Project	IEEE 802.16 Broadband Wireless Access Working Group <http://ieee802.org/16>
Title	Editorial changes in Cor1/D4 to resolve fast feedback inconsistency with .16e
Date Submitted	2005-09-09
Source(s)	Masoud Olfat (Sprint Nextel), Peiyong Zhu (Nortel) Charlie Zhang (Nokia)
Re:	IEEE P802.16 Cor1/D4
Abstract	
Purpose	Discuss and approve.
Notice	This document has been prepared to assist IEEE 802.16. It is offered as a basis for discussion and is not binding on the contributing individual(s) or organization(s). The material in this document is subject to change in form and content after further study. The contributor(s) reserve(s) the right to add, amend or withdraw material contained herein.
Release	The contributor grants a free, irrevocable license to the IEEE to incorporate material contained in this contribution, and any modifications thereof, in the creation of an IEEE Standards publication; to copyright in the IEEE's name any IEEE Standards publication even though it may include portions of this contribution; and at the IEEE's sole discretion to permit others to reproduce in whole or in part the resulting IEEE Standards publication. The contributor also acknowledges and accept

Figure 230a – Post Processing CINR for MIMO Region

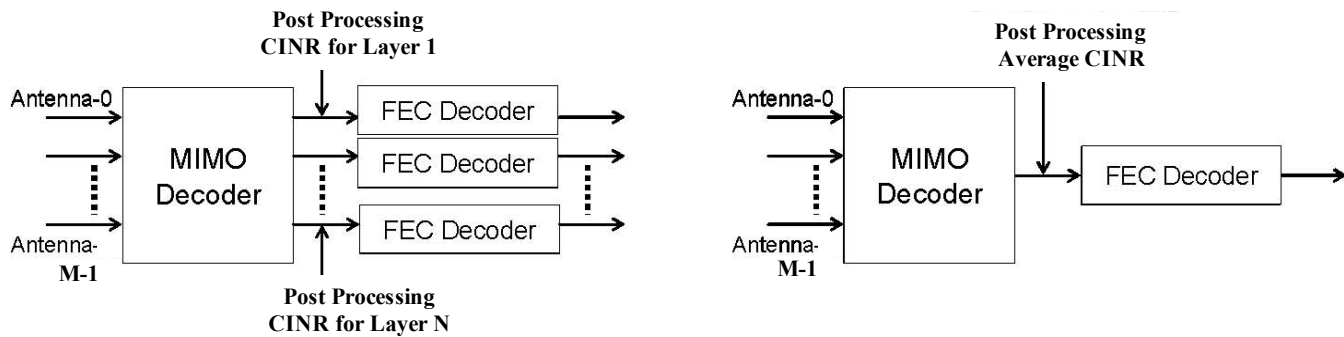
[Replace Figure 230a by the following figure]:
